RE: VEHICLE GROUND CLEARANCE ASESMENT: 1 – 3 GONDOLA RD, NORTH NARRABEEN, NSW

Martens and Associates (**MA**) have prepared this letter to present the results of a ground clearance assessment in response to the traffic engineer referral response (comment no.14) by Northern Beaches Council (**NBC**) (DA2024/0460, dated 09/08/2024).

Figure 1: Vehicle ingress along southern edge of ground floor ramp.

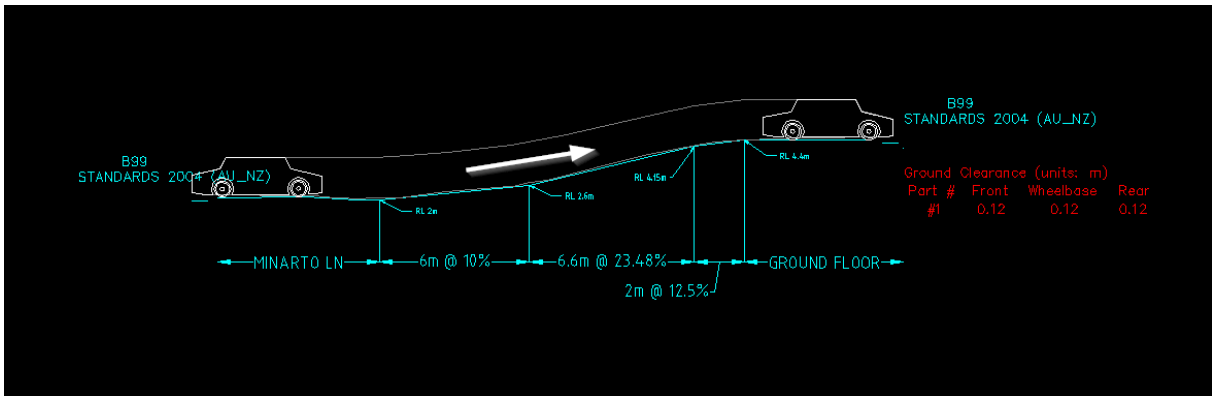
- Vehicle ingress along southern edge of ground floor ramp (see Figure 1).
- Vehicle egress along southern edge of ground floor ramp (see Figure 2).
- Vehicle ingress along northern edge of ground floor ramp (see Figure 3).
- Vehicle egress along northern edge of ground floor ramp (see Figure 4).
- Vehicle ingress along centre line of basement ramp (see Figure 5).
- Vehicle egress along centre line of basement ramp (see Figure 6).

A total of six ground clearance checks were carried out and no bottom scraping was found for B99 vehicle.
